6C Containment Debris Protection for ECCS Strainers

The information in this appendix of the reference ABWR DCD is subject to several changes due to the adoption of a complex ECCS strainer design (e.g. Cassette Type Strainer). Consequently, for clarity it is presented in its entirety with the following departures incorporated. This strainer design has been used at numerous BWRs in Japan and numerous PWRs in the United States. The strainer is described in this appendix. Departure STD DEP Vendor changes General Electric (GE) to Toshiba in Section 6C.1.

STD DEP 6C-1 (Figure 6C-1)

Figure 6C-1 Cassette Strainer Cutaway

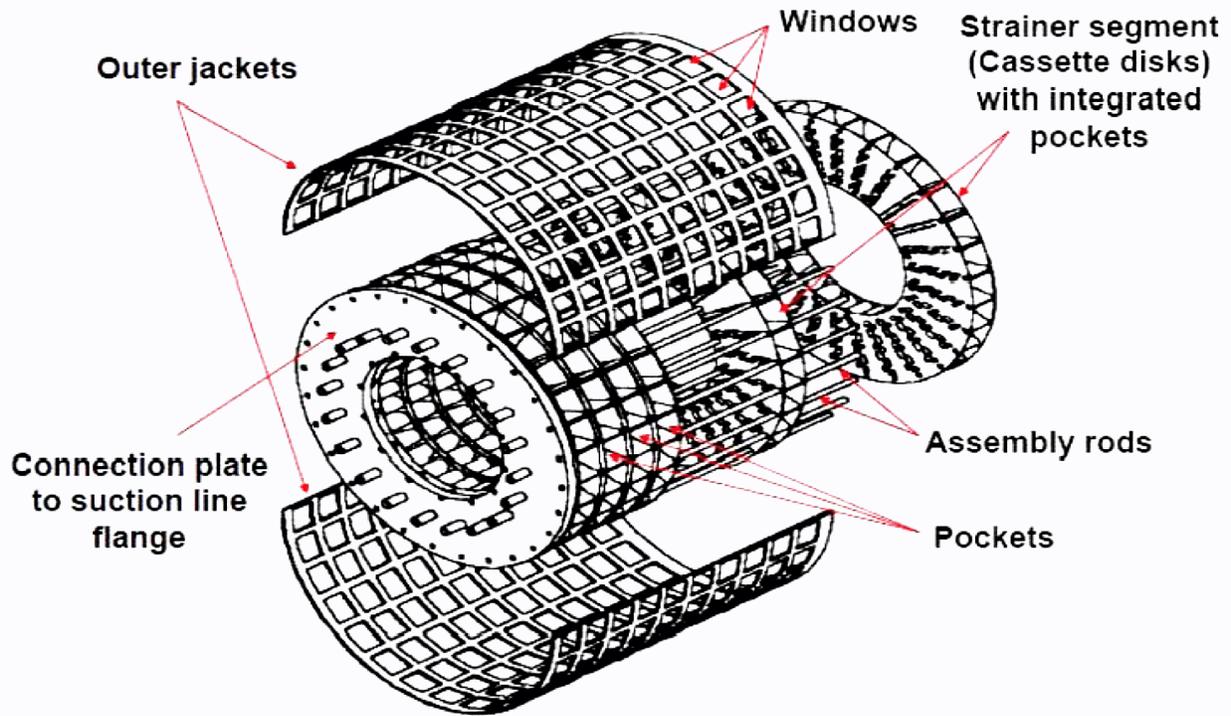
The suction strainers design at Perry preceded and did not meet the current regulatory requirements. The ABWR ECCS suction strainers will utilize a "T" arrangement with conical strainers on the 2 free legs of the "T" a cassette type strainer design. This design separates the strainers so that it minimizes the potential for a contiguous mass to block the flow to an ECCS pump. The design of the strainers will be based on Regulatory Guide 1.82, NUREG/CR-6224 (Reference 6C-4), NUREG/CR-6808 (Reference 6C-5) and the Utility Resolution Guidance, NEDO-32686-A. The cassette type strainer design is based on a set of cassette modules with U-shaped filter pockets attached to the cylindrical outer jacket. Each strainer consists of filter modules, the outer jacket and flange plates on each end of the cylindrical assembly. The filter module is constructed with cassettes which are arranged axially along the strainer axis. One cassette consists of pocket shaped filters which are arranged radially. A cut-away drawing of the strainer is shown in Figure 6C-1. The material used in the cassette type strainer is stainless steel. The cylindrical strainer assemblies are mounted in pairs on piping tees at each ECCS pump suction line. When the ECCS pump operates, the suction flow in the suppression pool runs into all pockets through the outer jacket windows. Each pocket has five flow paths from the inlet through the five perforated walls to the outlet of the pocket towards the cassette strainer. By using the cassettes with the pocket shaped filters, the strainer has an available filter area which is larger per volume than cylindrical and other shaped strainers. The number of cassettes and pockets is adjusted to produce a specific head loss performance for the strainer. To avoid debris clogging the flow restrictions downstream of the strainers, the size of the holes in the perforated sheets is chosen by considering specific flow paths of ECCS equipment and piping (for example, the containment spray nozzle and the ECCS pump seal cooling flow orifices). The strainers will have holes no larger than 2.1 mm.

- (6) ~~(5)~~ *The equipment installed in the drywell and wetwell minimize the potential for generation of debris.*
- (7) ~~The ECCS suction strainers~~ *The cassette-type ECCS strainers meet the current regulatory requirements unlike the strainers at the incident plants.*
